**CITY OF MERIDIAN
FINDINGS OF FACT, CONCLUSIONS OF LAW
AND DECISION & ORDER**

Case No(s). H-2024-0060

STAFF REPORT

SUBJECT: H-2024-0060
Lennon Pointe – PP, PS

A. Preliminary Plat (dated: 10/25/24)

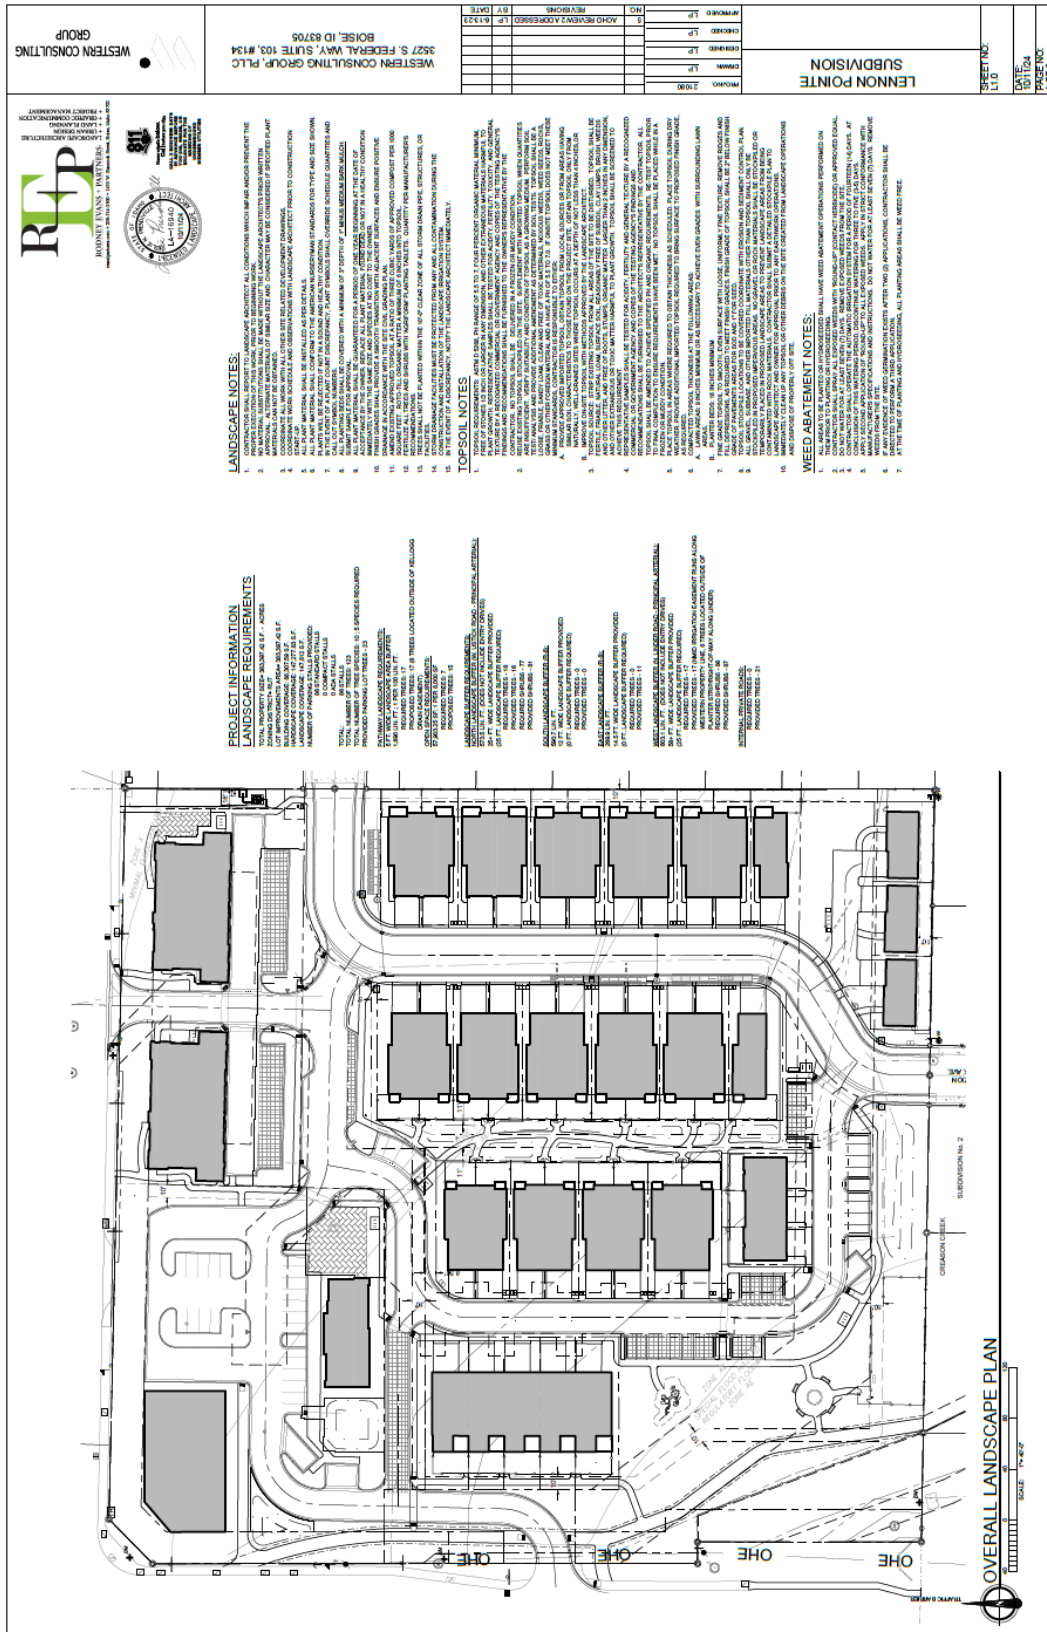
2. The final plat shall include the following revisions:
 - a. Widen Lots 14-16, Block 2 to accommodate the minimum front setback of 20-feet to the face of garage on these lots.

- b. Depict a minimum 20-foot wide perpetual ingress/egress easement on Lot 13 for the common driveway and include a note for the easement requiring maintenance of a paved surface capable of supporting fire vehicles and equipment in accord with UDC 11-6C-3D.8. Alternatively, a separate 20-foot wide common lot could be included for the common driveway.

- c. Plat note #7 includes incorrect common lot numbers; revise accordingly and remove the portion pertaining to the common driveway.
 - d. Depict a 26-foot wide easement for the private street on Lot 4, Block 1 and include a note granting an ingress/egress/cross-access easement to all lots in the subdivision to use the private streets on Lot 4, Block 1.

- g. The private street shall be a loop off the local street (i.e. N. Zion Park Ave./W. Pebblestone Dr.) and shall not extend to the west of N.W. 15th Ln. along the north side of Lot 11, Block 1; the private street shall terminate on the west side of N.W. 15th Ln.

- h. Depict an access easement for the driveway proposed via N. Linder Rd. to the commercial property on Lot 3, Block 1 and for the driveway along the north side of Lot 11, Block 1 between the townhomes and commercial lot; the easements should grant access to all lots within the subdivision.

- j. Depict an ingress-egress easement across Lots 2 and 3, Block 1 granting access to all lots in the subdivision.
3. The landscape plan, included in Section VII.D, shall be revised as follows prior to submittal of the Final Plat application:

E. Open Space Exhibit (date: 10/11/2024) & Amenity Detail

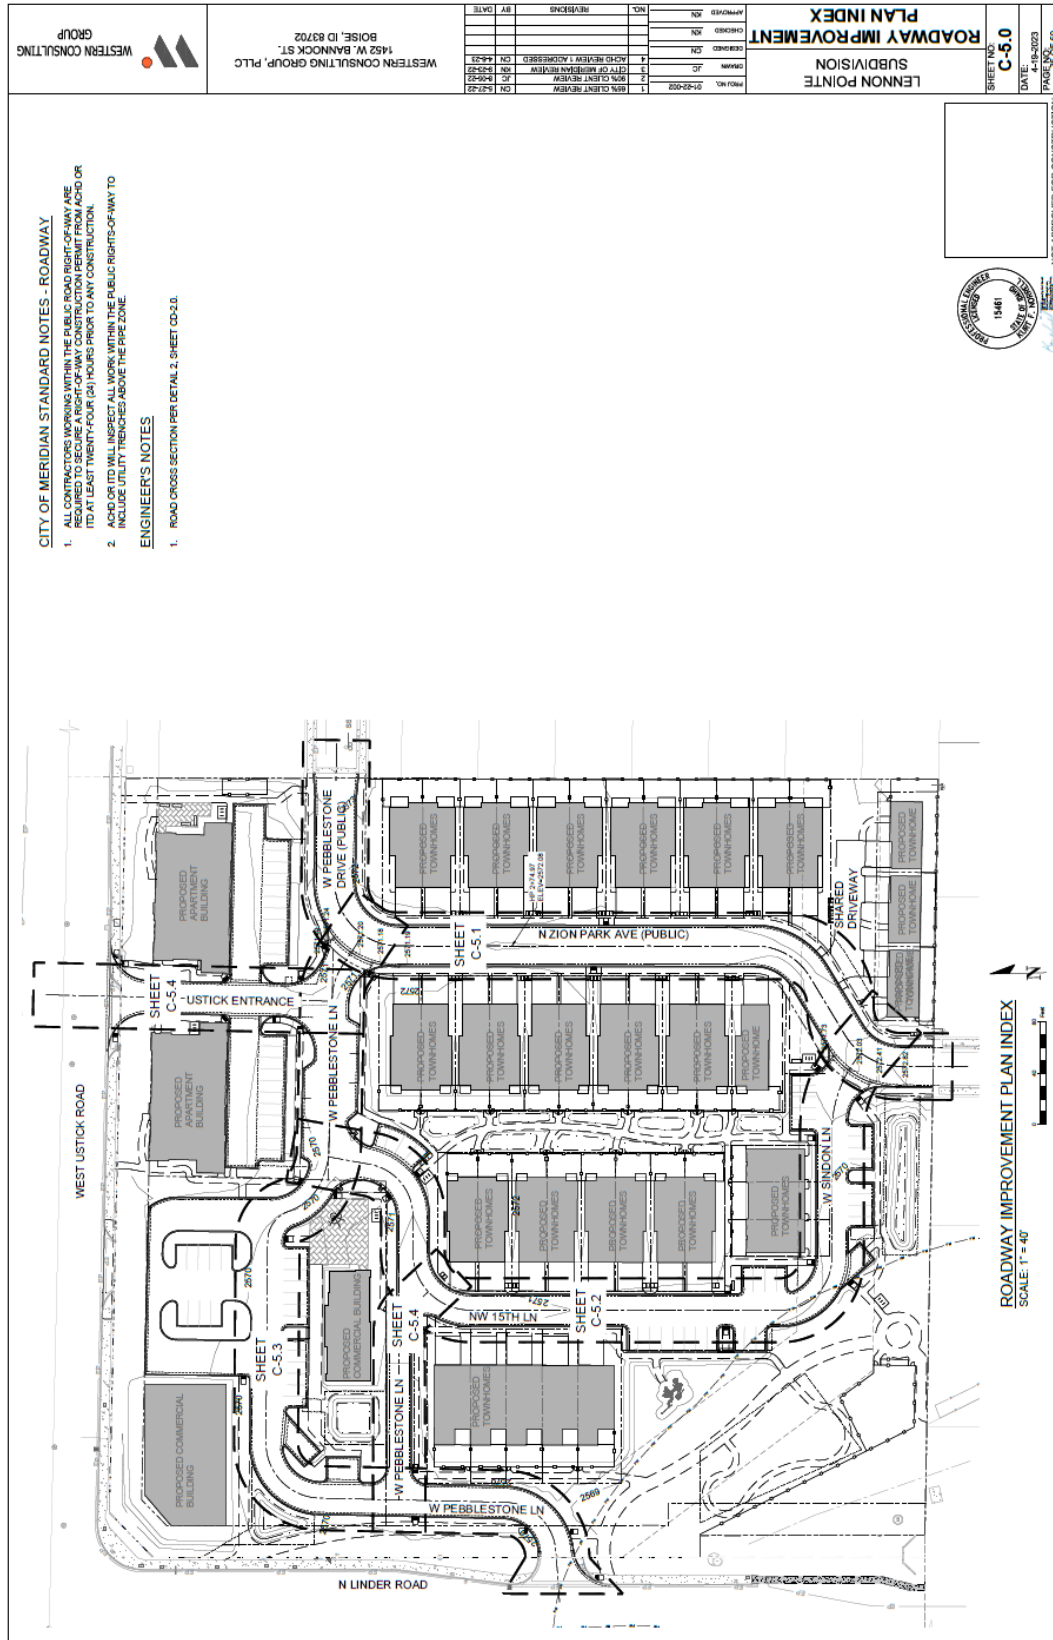
Based on 6.96-acres, a minimum of 1.05-acres of qualified open space is required; the open space exhibit submitted with this application, included below in Section VII.E, depicts a total of 1.33-acres (or 19.07%). Proposed open space consists of linear open space exceeding 20' x 50' in area with an access at each end improved with landscaping, open grassy areas exceeding 5,000 square feet in area, 50% of the arterial street buffers along Linder & Ustick Roads, stormwater retention facility, and a plaza with a minimum dimension of 20' in all directions, which meets and exceeds UDC standards.
